Section 16 Planning Application for Proposed Mixed-Use Development (Proposed Flat with Permitted Commercial Uses) with Minor Relaxation of Building Height Restriction at Lot 4354 in D.D. 124, Kiu Tau Wai, Yuen Long (Application No. A/HSK/617)

Response to Departmental Comments

SHEET NUMBER
60640967/SIA/FIGURE 4

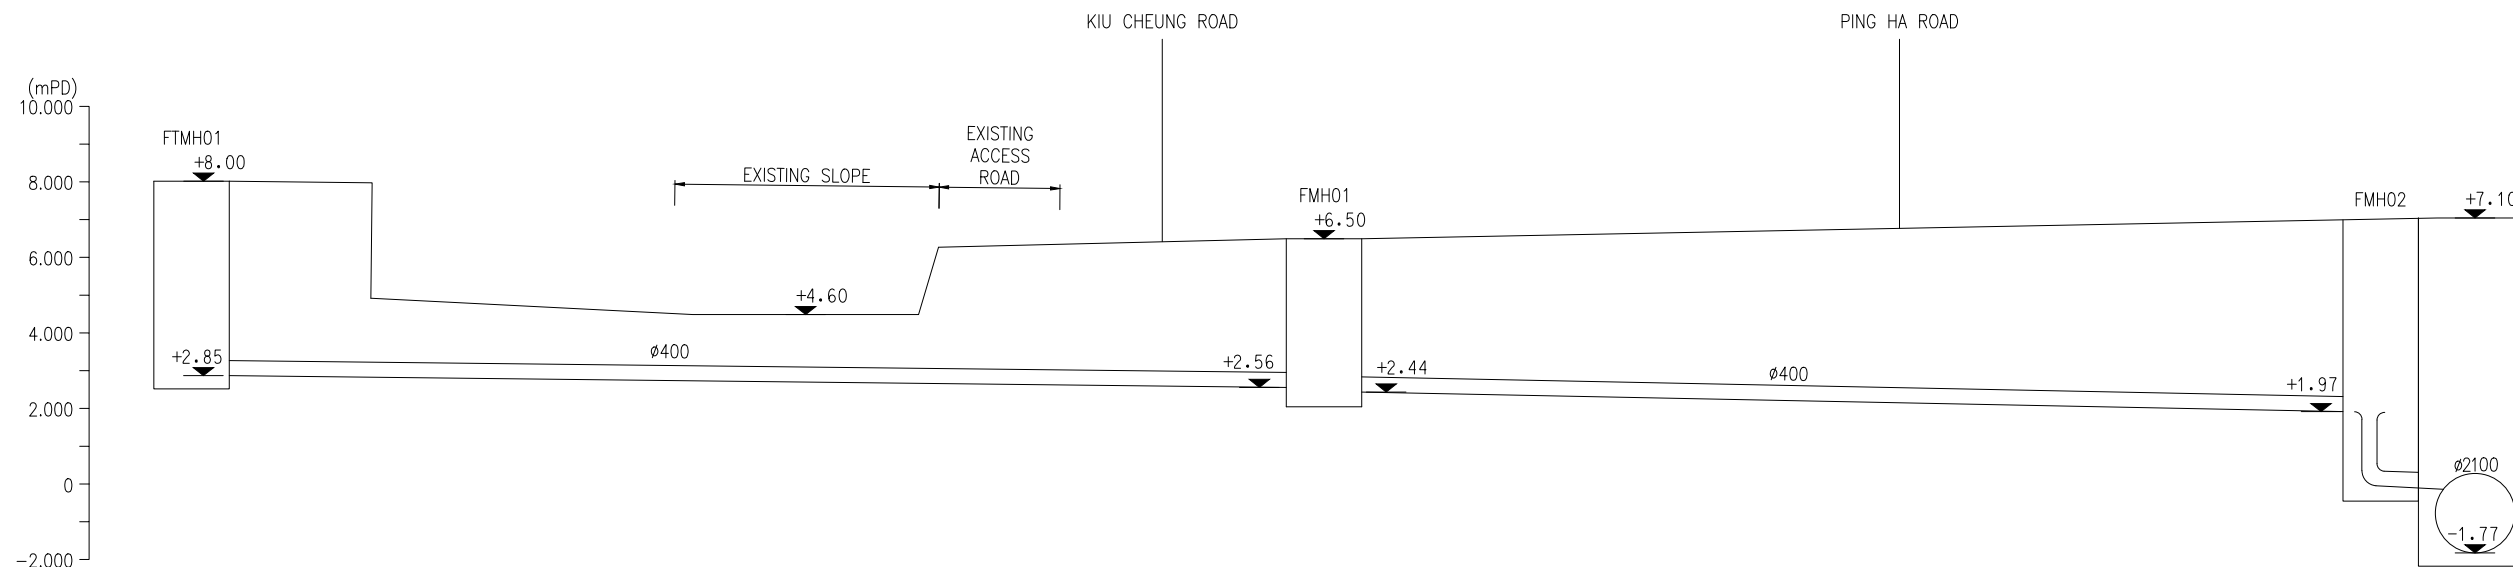
3.12	Please provide the connection details at the discharge point and indicate relevant details (e.g., cover level, invert level, and D.T.L.) on the drawing.	A new manhole FMH02 will be constructed between existing manholes FMH1008961 and FMH1008968 for the new 400mm sewer to discharge at slightly higher level. Please refer to the updated Figures 4 and 5 of the SIA replacement pages under Attachment 6 .
